ERL and System Performance for 50GBASE-CR

Presented at May 2018 Pittsburgh interim.

- This presentation is related to comment r02-15, and also investigates the effect on system performance as measured by COM of changes in ERL parameters and specifications. It builds on work presented in dudek_3cd_01_0318.

COM vs. adjusted Host ERL (comment: rho=0.3 beta_x=1.7 N=300 Grr_limit=1) All points meet Pmax/Vf spec

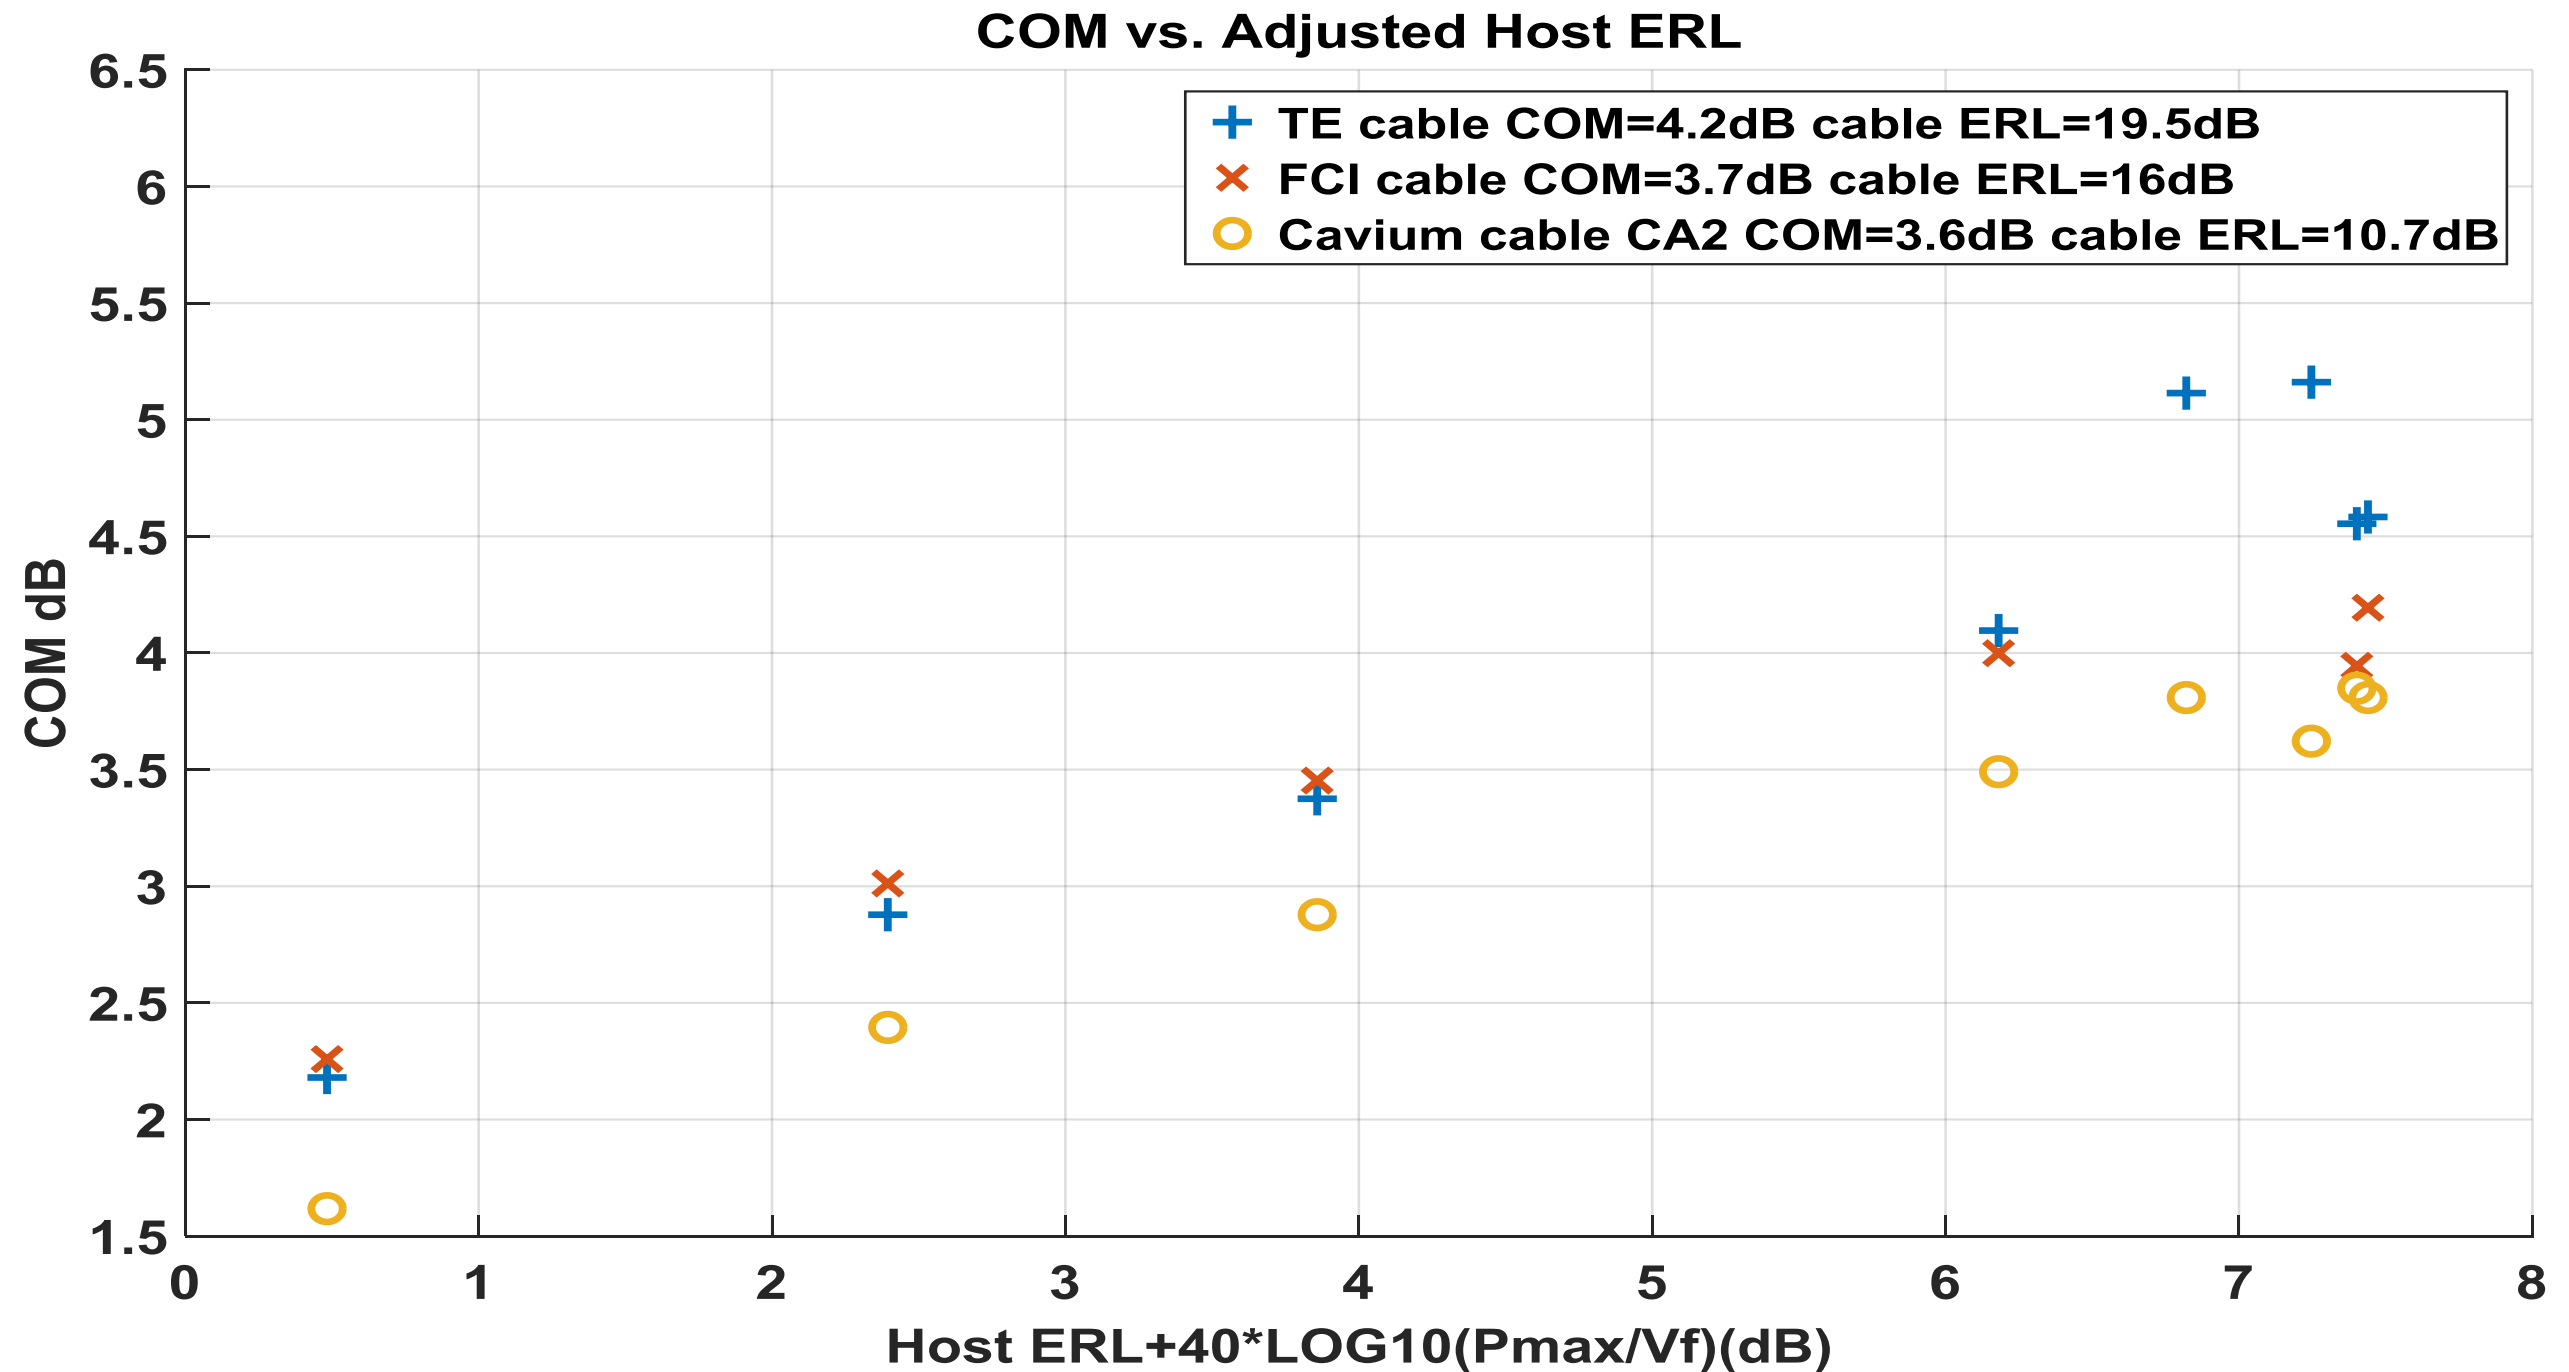
- **The proposed changes to the ERL parameters result in different ERL values (approximately 3dB lower). There are technical justifications for the changes and we recommend they are accepted but the ERL pass/fail limit needs to be adjusted.**
- **The short hosts provide good system performance on these cables and are a likely implementation. They should pass the Tx specification.**
- **The long host with the Cb capacitance at 0.3pF provides bad system performance on all these cables (and particularly CaviumCA2). It should fail the Tx specification.**
- **It has been proposed that the specification should be a single value of ERL, a single value of SNR_{Risi} or a combination of a single value of ERL plus a single value of SNR_{Risi} however no single values for these parameters exists that will not have false passes or false fails with these hosts.**

- **The new ERL parameters should be adopted.**
- **A specification of $ERL \geq 4dB - 40 * \text{Log}_{10}(P_{max}/V_f)$ should then be adopted.**
- **Note that it has been suggested that it is inconvenient having this combined specification as ERL is generally measured with a VNA and post processing and P_{max}/V_f is measured with an oscilloscope and post processing. With this specification however test engineering could choose to use fixed pass/fail values for the testing of their product depending on the product type with a choice of paired values. E.g.**
 - $P_{max}/V_f \geq 0.49$ $ERL \geq 16.4$
 - $P_{max}/V_f \geq 0.55$ $ERL \geq 14.4$
 - $P_{max}/V_f \geq 0.63$ $ERL \geq 12.0$
